CITY OF ALBUQUERQUE

RE: **Lot 6 Block 10 Volcano Cliffs Unit 22 SAD 228**
6412 Petirrojo Rd. NW
Grading and Drainage Plan
Engineers Stamp Date 7/30/2021 (D10D003F6)
Pad Certification Date 11/2/2021

RE: **Lot 6 Block 10 Unit 22 SAD 228
6412 Petirrojo Rd. NW
Volcano Cliffs Subdivision
Grading and Drainage Plan
Engineers Stamp Date 10/12/2021 (D10D003F6)**

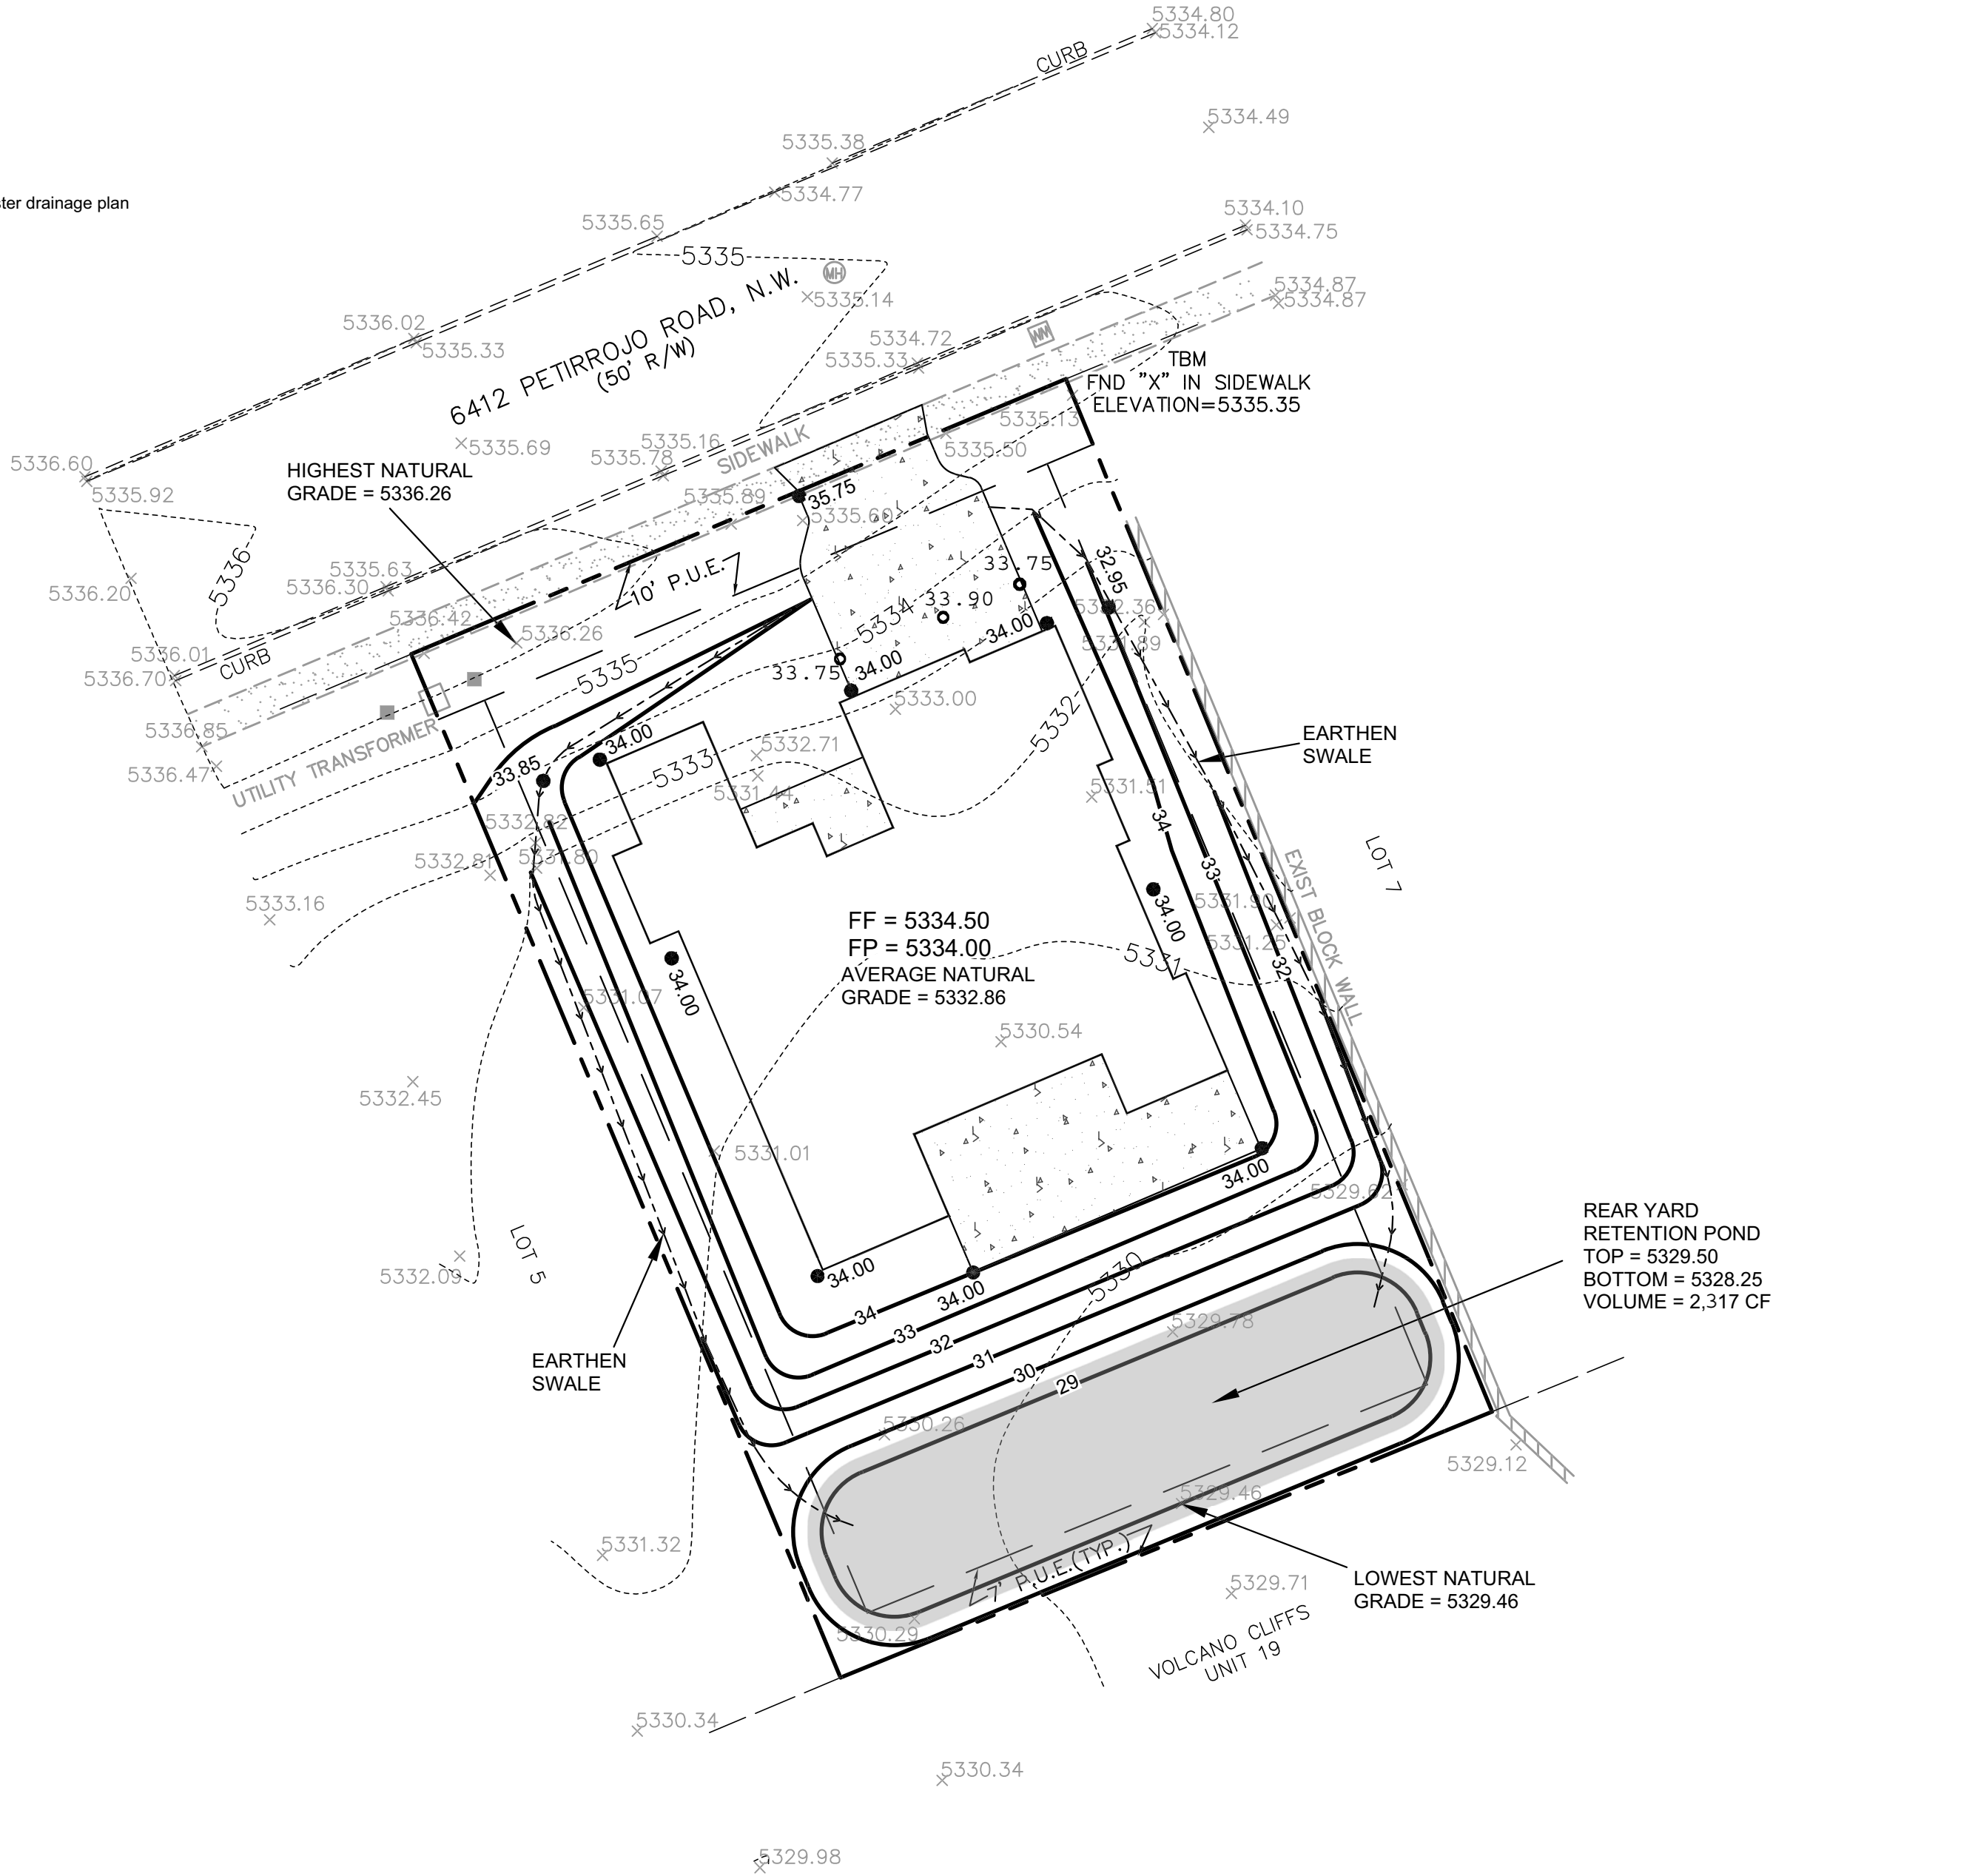
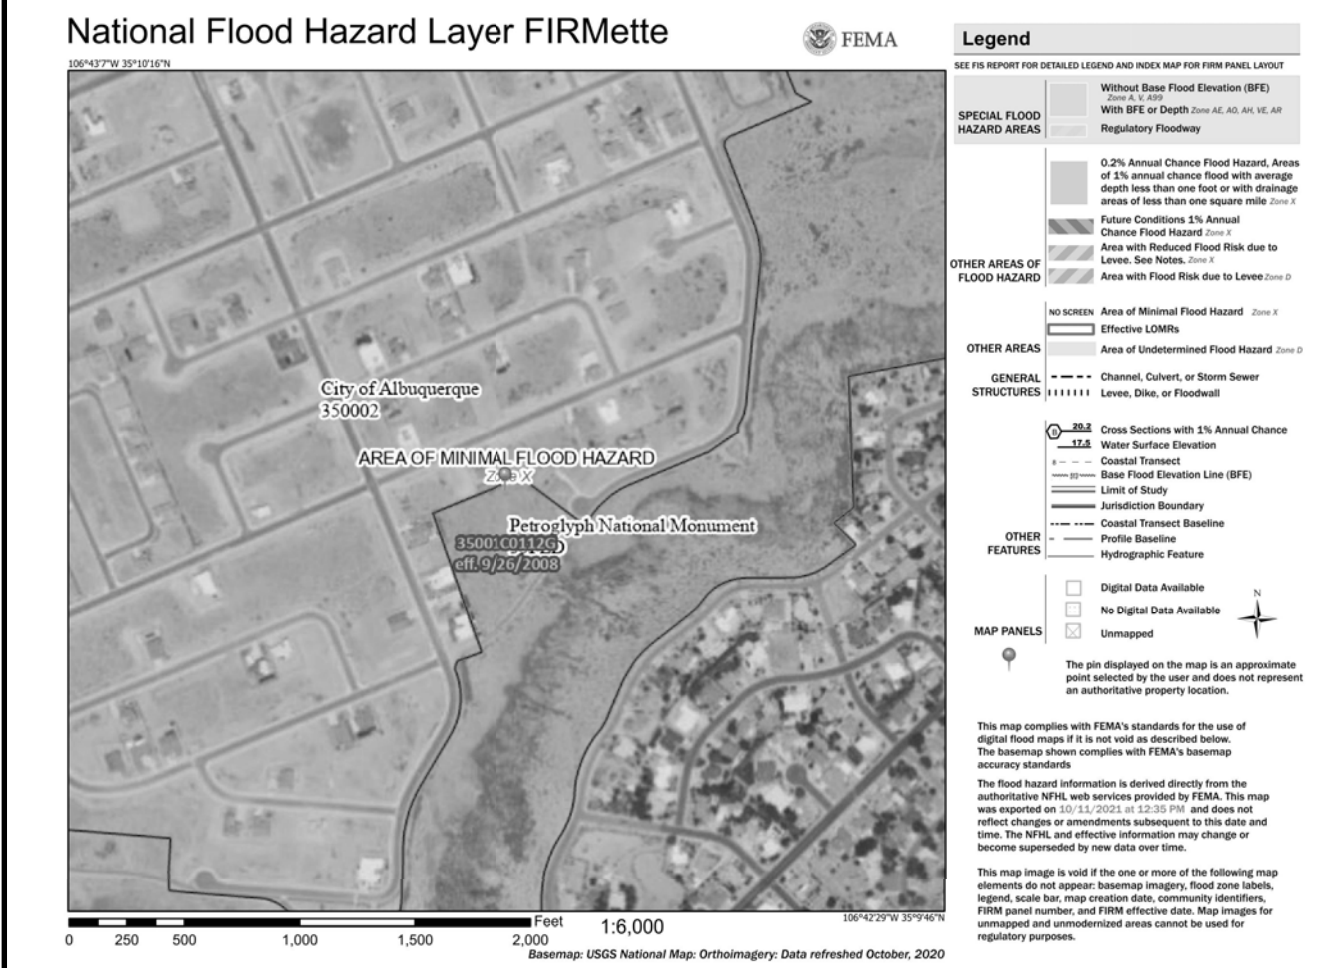
Based upon the information provided in your submittal received 10/12/2021, this plan is approved for Grading Permit.

Prior to Building permit approval a Pad Certification will be required, provided by the Engineer or a registered Land Surveyor.

Advise the owner contractor not to use dirt as a ramp to climb the curb, use lumber or crusher fines for this purpose.

Reiterate to the Owner/Contractor that a separate permit for a garden/retaining wall must be obtained with the approved G&D plan and Pad Certification. Also, if a swimming pool is to be placed after this approval a new grading and drainage plan will need to be resubmitted showing the changes for the land treatments.

Prior to Certificate of Occupancy release, Engineer Certification per the DPM checklist is required.

ENGINEER'S SEAL	LOT 6 BLK 10 UN 22 VC 6412 PETIRROJO ROAD	DRAWN BY DEM

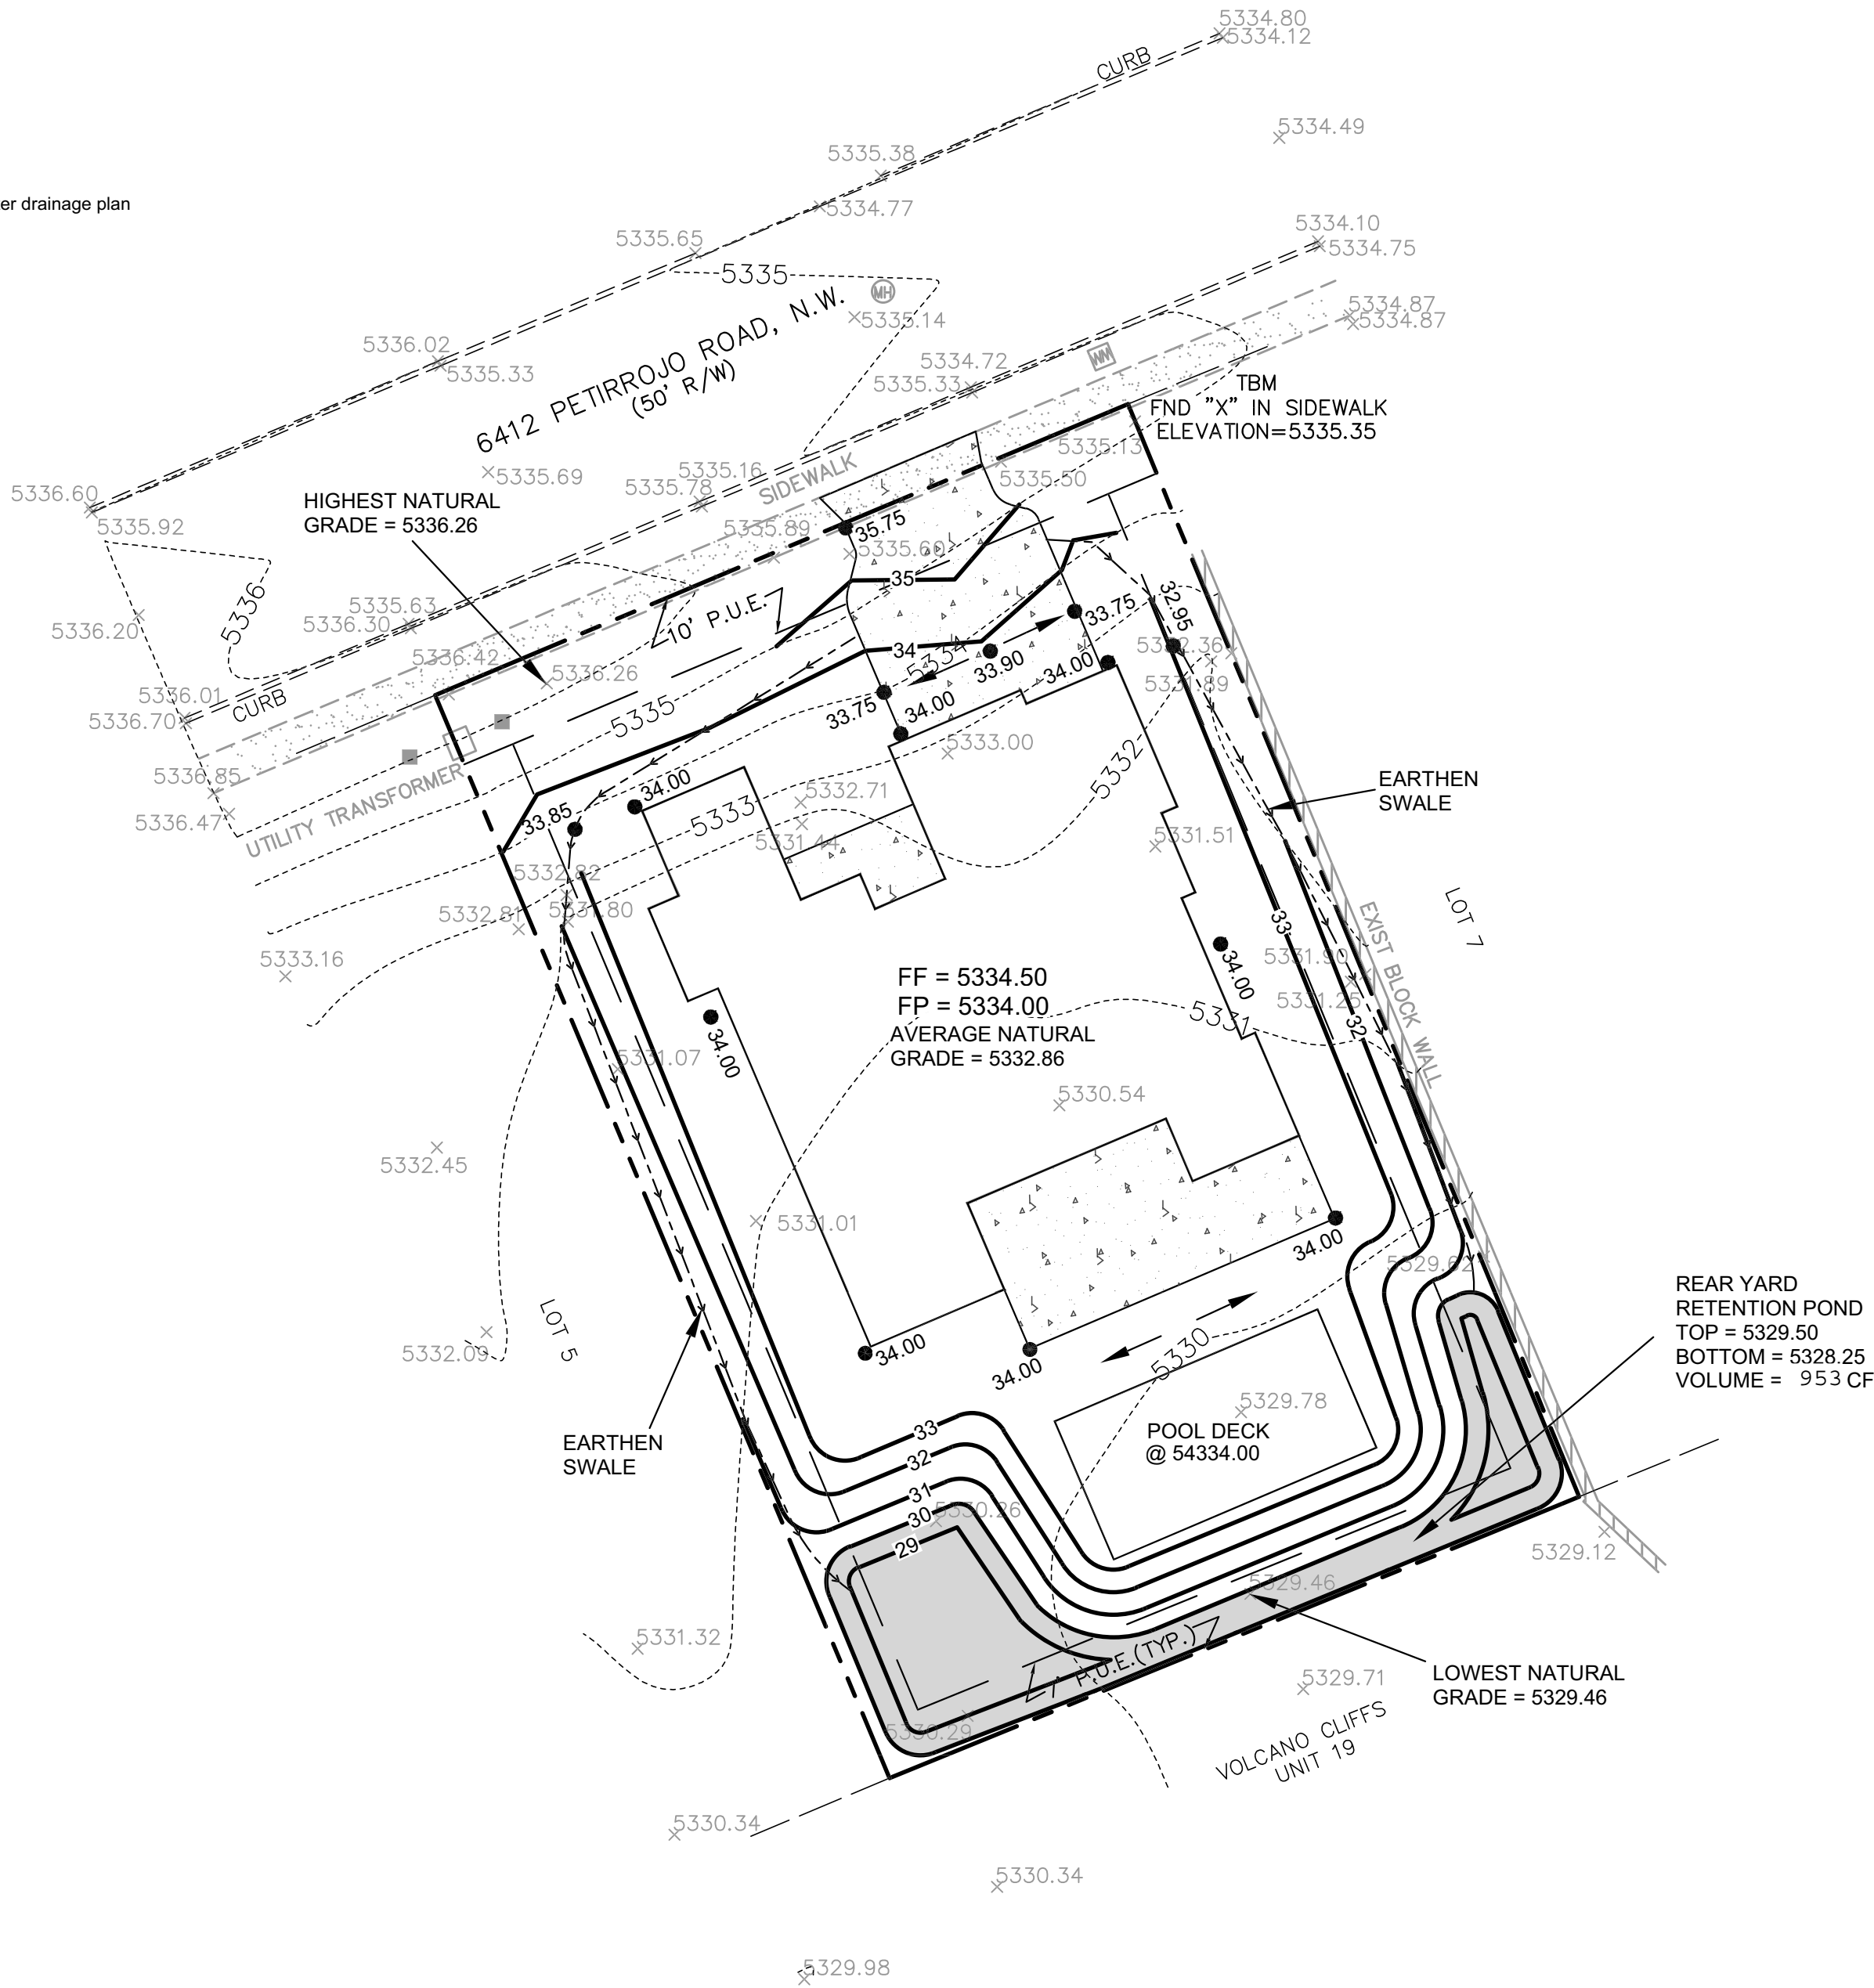
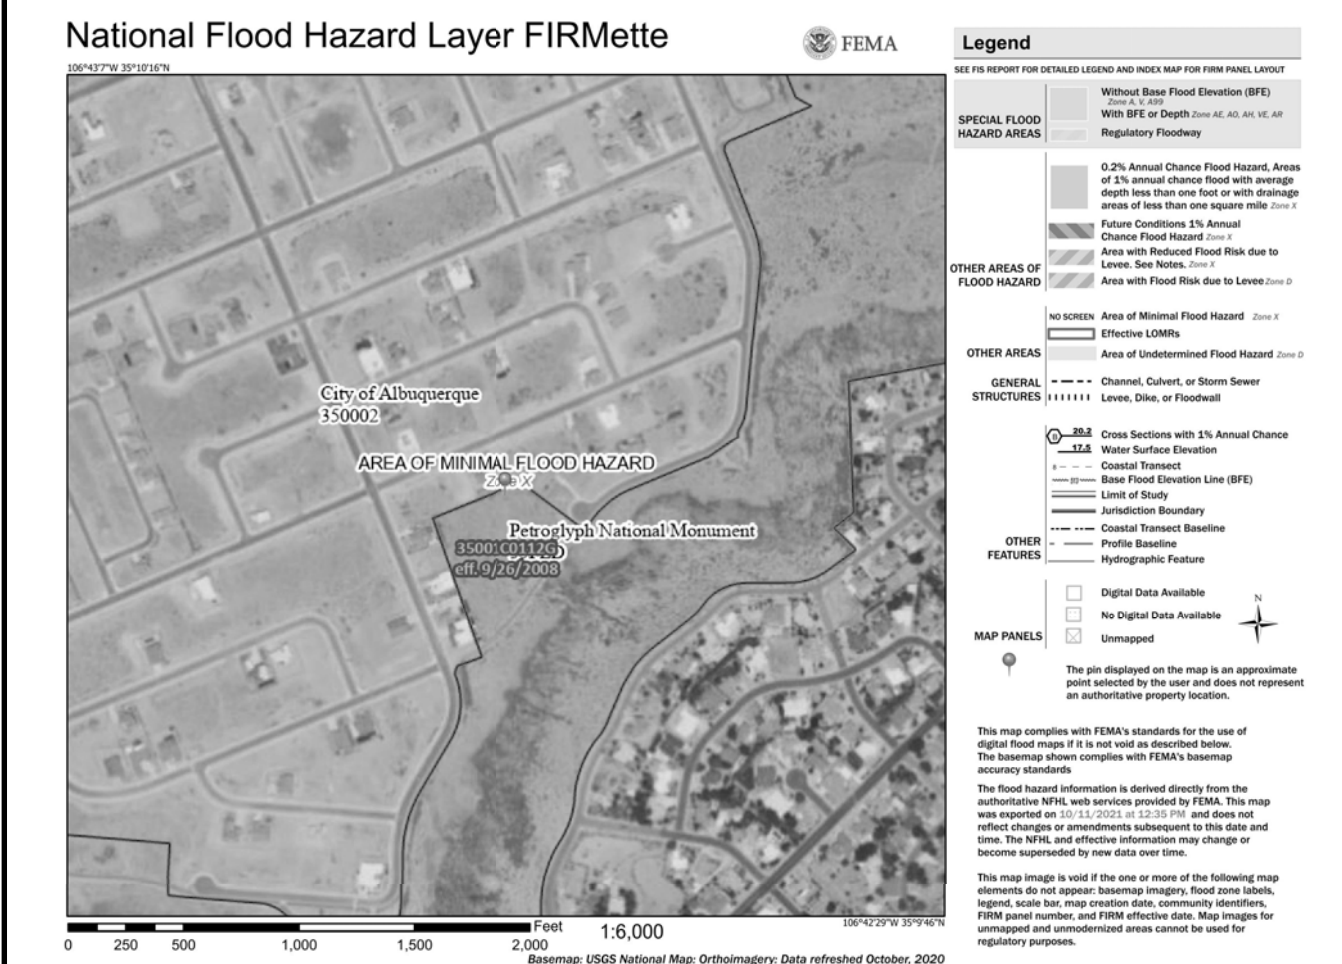
Based upon the information provided in your submittal received 11/16/2021, this plan is approved for Building Permit.

Please inform the builder/owner to attach a copy of this approved plan and this letter to the construction sets in the permitting process prior to sign-off by Hydrology.

Reiterate to the Owner/Contractor that a separate permit for a garden/retaining wall must be obtained, with the approved G&D plan and Pad Certification. Also, let the owner/contractor know that if a pool is to be added in the future the G&D plan will need to be modified showing the location of the pool and the land treatment differences. Also advise the owner & Contractor that dirt is not allowed in the public right of way to climb the curb. Crusher fines or lumber is allowed. If dirt is used this will delay going forward with the construction of the home.

Prior to Certificate of Occupancy release, Engineer Certification per the DPM checklist of this plan will be required.
